Project	IEEE 802.16 Broadband Wireless Access Working Group < <a href="http://ieee802.org/16">http://ieee802.org/16</a> >	
Title	Fix for Uplink PUSC Space Time Coding	
Date Submitted	2005-09-09	
Source(s)	Jun WU, Wenzhong Zhang, Wenfeng Zhang, Sean Cai, Jing Wang, Yunsong Yang	<a href="mailto:jwu@ztesandiego.com">jwu@ztesandiego.com</a> <a href="mailto:wzhang@ztesandiego.com">wzhang@ztesandiego.com</a>
	ZTE San Diego Inc. 10105 Pacific Heights Blvd. San Diego, CA 92121 USA	
Re:	Response to Sponsor Ballot Recirculation on IEEE802.16e D10 document	
Abstract	In this contribution, we propose to a fix for Uplink PUSC STC	
Purpose	To incorporate the text changes proposed in this contribution into the IEEE802.16e_D11 draft.	
Notice	This document has been prepared to assist IEEE 802.16. It is offered as a basis for discussion and is not binding on the contributing individual(s) or organization(s). The material in this document is subject to change in form and content after further study. The contributor(s) reserve(s) the right to add, amend or withdraw material contained herein.

## Fix for Uplink PUSC Space Time Coding

Fig. 249 UL STC tile

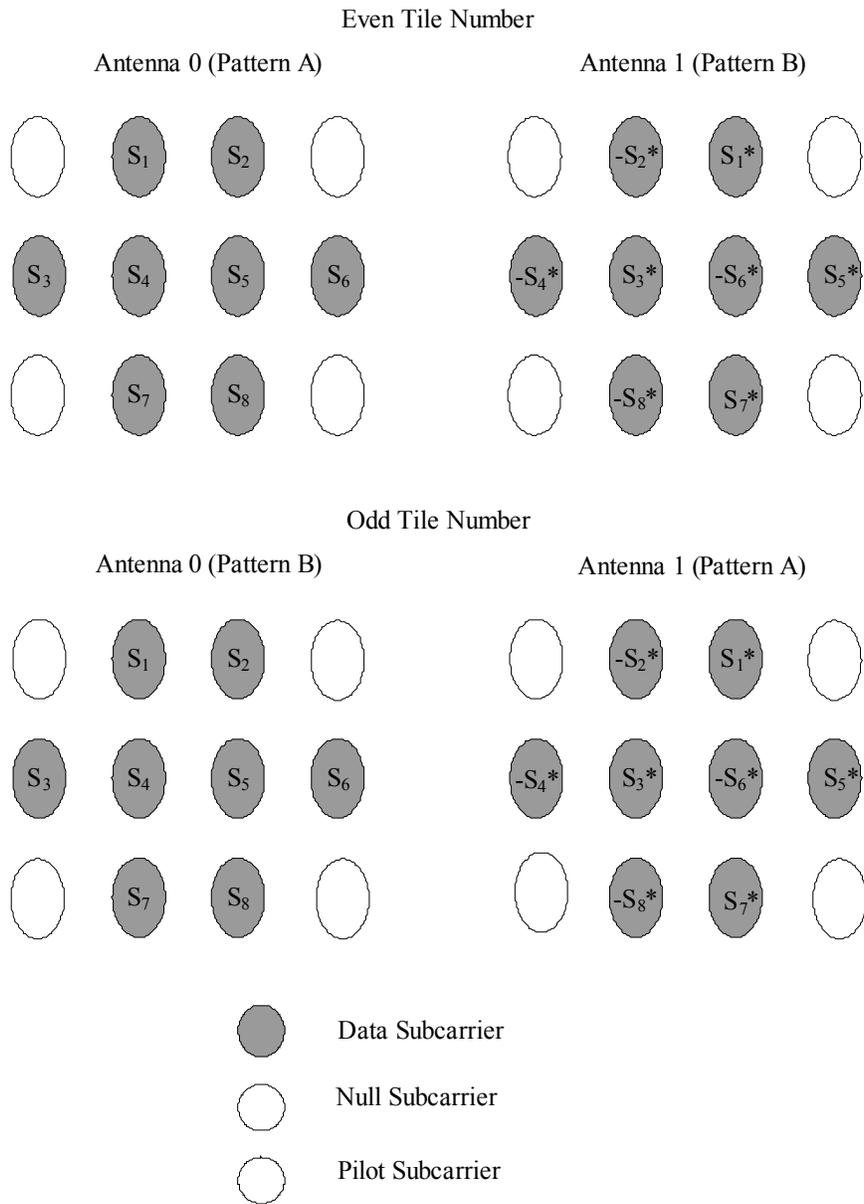
In the current standard, the data and pilot subcarriers mapping for uplink pusc space time coding are defined as Fig. 249 in 8.4.8.1.5. S1 and S2, S3 and S4, S5 and S6, S7 and S8 are four pairs of signals, which construct 2-antenna space time coding. In Base Station receiver, if OFDM symbol and frequency synchronization is perfect, the channel of adjacent subcarriers can be regarded similar, then space time decoding is easy.

In reality, the Base Station is impossible to guarantee that all the SSs arrive at BS at exactly the same time, and residual frequency offset very possibly exists due to oscillator inaccuracy and Doppler shift. For non STC coding, channel estimation can cover both symbol and frequency offset because 4 pilot tones are available. For STC coding, only two pilot tones are available, performance degradation is dramatic.

We propose to use pilot pattern A and B alternately for antenna 0 and 1, as shown in Fig. 249. For the even tiles, antenna 0 uses pilot pattern A and antenna 1 uses pilot pattern B; For the odd tiles, antenna 0 uses pilot pattern B and antenna 1 uses pilot pattern A.

The intention is to estimate the phase offset caused by symbol and frequency offset respectively. Suppose the phase offset  $\theta_s$  and  $\theta_f$  represent phase rotation of symbol and frequency of antenna 0, differentiate the pilot tones of the even tiles, we get  $e^{j\theta_s} e^{j\theta_f}$ , differentiate the pilot tones of the odd tiles, we get  $e^{-j\theta_s} e^{j\theta_f}$ , so it is easy to solve both phase offsets for antenna 0. The same procedure can apply to antenna 1.

*Change the following text and figure 249 in 8.4.8.1.5.*

A user-supporting transmission using STC configuration in the uplink, shall use a modified uplink tile, 2-transmit diversity data ('STTD mode'), or 2-transmit spatial multiplexing ('SM mode') data that can be mapped onto each subcarrier. The mandatory tile shall be modified to accommodate those configurations. In STTD mode, the tiles shall be allocated to subchannels and the data subcarriers enumerated as defined in 8.4.6.2. **The pilot in each tile shall be split between the two antennas, for the even tiles, antenna 0 uses pattern A and antenna 1 uses pattern B; for the odd tiles, antenna 0 uses pattern B and antenna 1 uses pattern A. The data subcarriers shall be encoded in pairs after constellation mapping, as depicted in figure 249. ~~The pilots in each tile shall be split between the two antennas and the data subcarriers shall be encoded in pairs after constellation mapping, as depicted in figure 249.~~** The data subcarriers transmitted from Antenna #0 follow the original mapping defined in 8.4.6.2.
